In the Matter of )  
AP1000 Design Certification Amendment ) NRC-2010-0131  
10 CFR Part 52 ) RIN 3150-A18

PETITION BY THE AP1000 OVERSIGHT GROUP ET AL.  
TO REQUIRE DESIGN ISSUES TO BE RESOLVED  
PRIOR TO CERTIFICATION

**FUKUSHIMA**  
and the  
**Westinghouse-Toshiba**  
**AP1000**

**A Report For The AP1000 Oversight Group**  
**By Fairewinds Associates, Inc**

Photo from Fukushima Nuclear Power Plant Accidents – Note Loss of Ultimate Heat Sink (LoUHS)

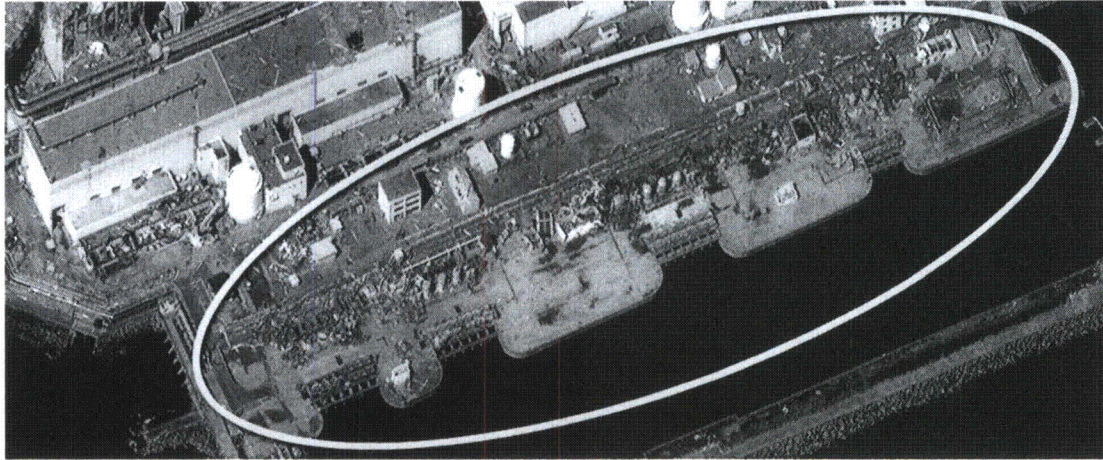
The photograph below shows that all (8) of the emergency service water pumps at Fukushima were destroyed following the tsunami. This inability to cool the reactors by emergency means is called a Loss of the Ultimate Heat Sink (LoUHS).

In SECY-11-0137 the Fukushima Near Term Task Force acknowledged that one of the root causes of the four Fukushima nuclear accidents was LoUHS.

**The photo below indicates the quantity of debris generated when a single reactor on a multiunit site explodes. Debris generated in this event directly applies to issues 2.4 through 2.6.**

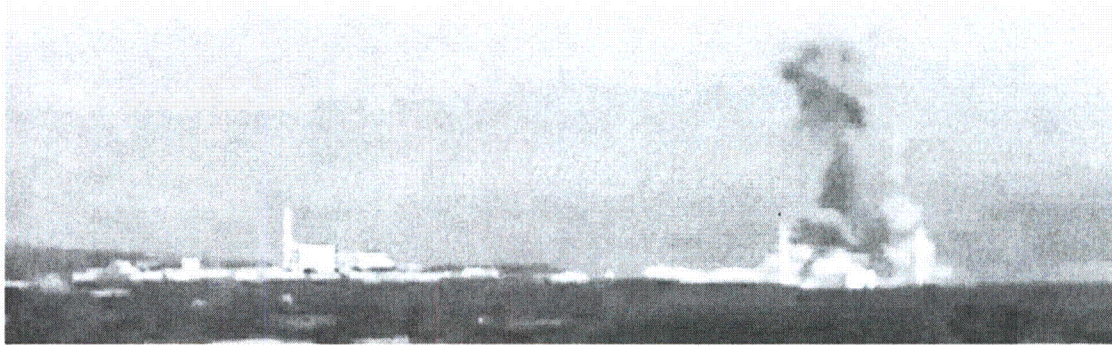
- 2.3 Many of the AP1000 nuclear power plants are being considered for multiunit power plant sites. What could happen to the extremely vulnerable AP1000 Passive Cooling System water tank if adjacent nuclear power plants at a multiunit site had explosions? Flying debris is plainly visible in the videos of the Fukushima #1 explosion, and that flying debris damaged adjacent nuclear power plants. When Fukushima #3 exploded only several days later, debris once again flew everywhere.

- 2.4 The AP1000 cooling design is dependent upon airflow into the annular gap surrounding the containment. Clogging of the vents on the AP1000 Shield Building due to debris from the explosion of adjacent nuclear units at a multiunit site, like the proposed Vogtle and VC Summer sites, could impede airflow into the annular gap surrounding the AP1000 Containment if an adjacent unit exploded. Large quantities of rubble and flying debris are plainly visible in the photographs first taken when Fukushima #1 exploded and again when Fukushima #3 exploded several days later. Such dust and rubble could easily hamper the effectiveness of the AP1000 cooling design and cause inadequate heat transfer on the outside surface of the AP1000 Containment Building due to debris from the explosion of adjacent nuclear units at a multiunit site. Both the Plant Vogtle and VC Summer proposed AP1000 units are on multi-unit sites and therefore will be extremely vulnerable to an accident from the blocked vents on the AP1000 Shield Building. Therefore, it is imperative that the Design Certification be held up until this issue is reviewed and adequate changes are made to the multi-unit sites prior to Design Certification, issuance

- 2.5 A clean smooth heat transfer surface is required for the AP1000 Containment to transfer heat to the air into the annular gap. As seen in the Fukushima explosion photo above, large amounts of dirt, dust, and debris are generated when there is a nuclear power plant explosion. On a multiunit site, such dirt and dust could hinder the ability of the AP1000 Containment to transfer heat into the air of the annular gap.
